PHILADELPHIA ELECTRIC COMPANY
DOCKET NO. 50-352
LIMERICK GENERATING STATION, UNIT 1
AMENDMENT TO FACILITY OPERATING LICENSE

Amendment No. 54
License No. NPF-39

ATTACHMENT TO LICENSE AMENDMENT NO. 54

PHILADELPHIA ELECTRIC COMPANY
DOCKET NO. 50-353
LIMERICK GENERATING STATION, UNIT 2
AMENDMENT TO FACILITY OPERATING LICENSE

Figure 4.7.4-1

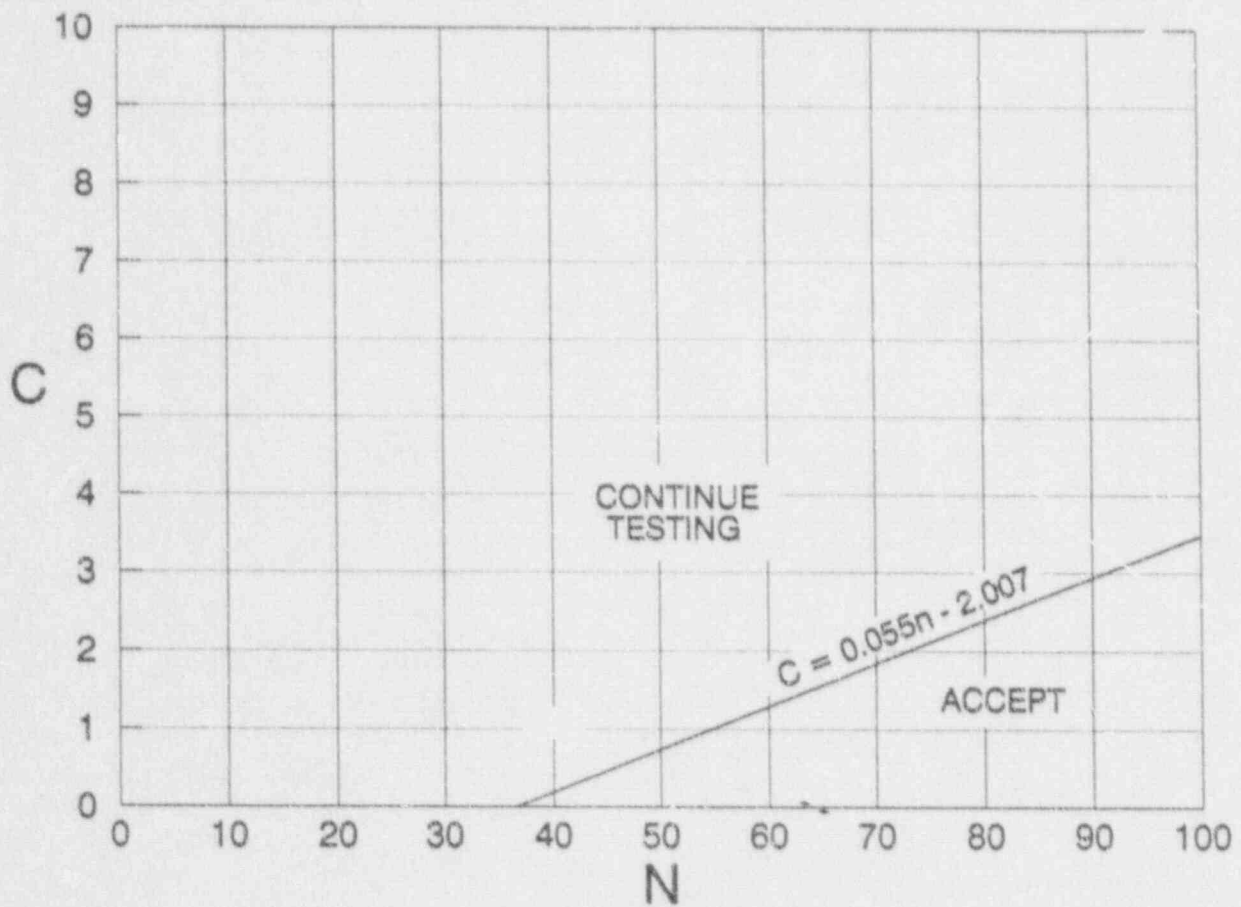
- 2) A representative sample of 37 snubbers of a snubber type shall be functionally tested in accordance with Figure 4.7.4-1. "C" is the total number of snubbers of that type found not meeting the acceptance requirements of Specification 4.7.4f. The cumulative number of snubbers of the type tested is denoted by "N". If at any time the point plotted falls in the "Accept" region, testing of snubbers of that type may be terminated. When the point plotted lies in the "Continue Testing" region, additional snubbers of that type shall be tested until the point falls in the "Accept" region, or all the snubbers of that type have been tested.

1. Functionally test 10% sample of a type of snubber with an additional 1/2 sample tested for each functional testing failure, or
2. Functionally test 37 snubbers and determine sample acceptance using Figure 4.7.4-1.

Figure 4.7.4-1 was developed using "Wald's Sequential Probability Ratio Plan" as described in "Quality Control and Industrial Statistics" by Acheson J. Duncan.

Figure 4.7.4-1
 SAMPLE PLAN 2) FOR SNUBBER FUNCTIONAL TEST

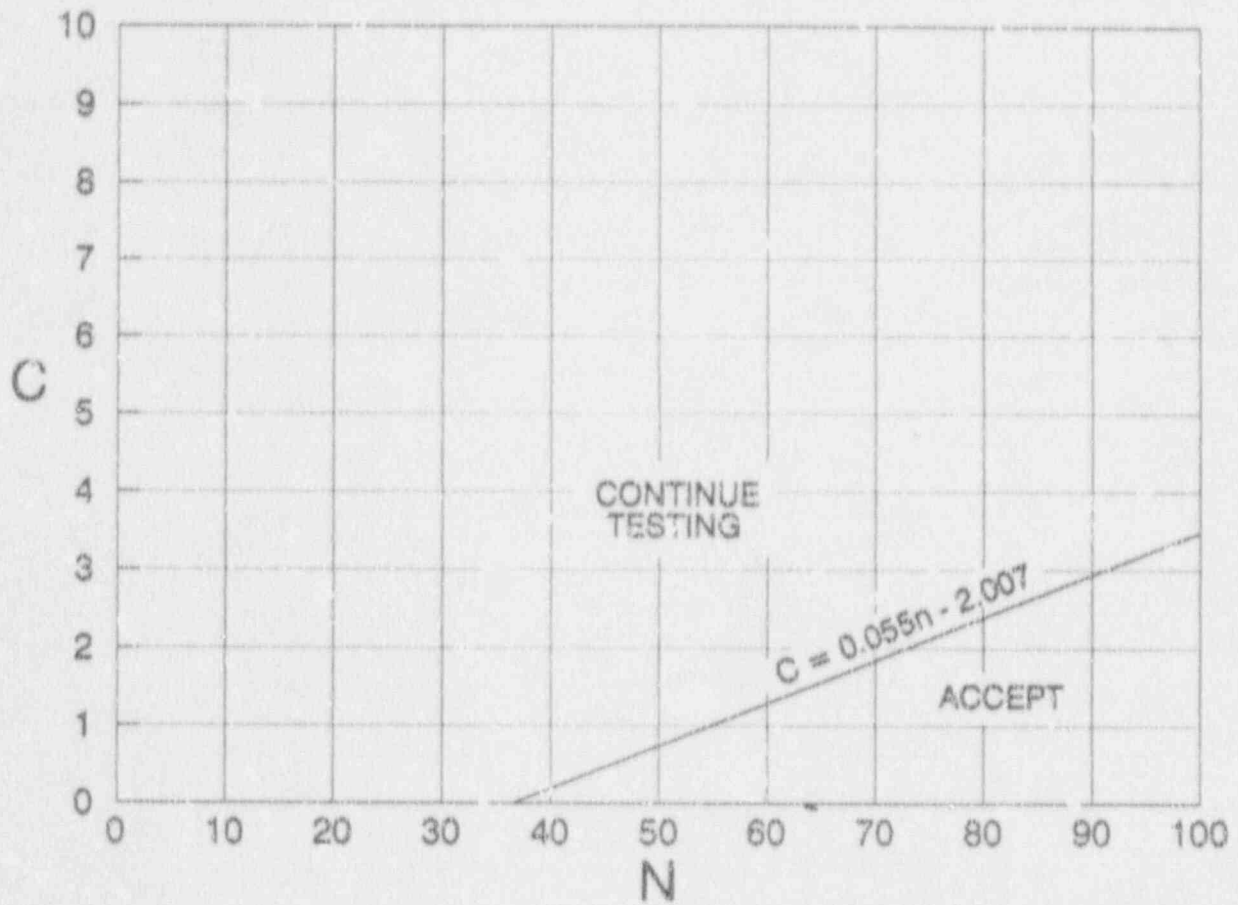
- 2) A representative sample of 37 snubbers of a snubber type shall be functionally tested in accordance with Figure 4.7.4-1. "C" is the total number of snubbers of that type found not meeting the acceptance requirements of Specification 4.7.4f. The cumulative number of snubbers of the type tested is denoted by "n". If at any time the point plotted falls in the "Accept" region, testing of snubbers of that type may be terminated. When the point plotted lies in the "Continue Testing" region, additional snubbers of that type shall be tested until the point falls in the "Accept" region, or all the snubbers of that type have been tested.

1. Functionally test 10% sample of a type of snubber with an additional 1/2 sample tested for each functional testing failure, or
2. Functionally test 37 snubbers and determine sample acceptance using Figure 4.7.4-1.

Figure 4.7.4-1 was developed using "Wald's Sequential Probability Ratio Plan" as described in "Quality Control and Industrial Statistics" by Acheson J. Duncan.
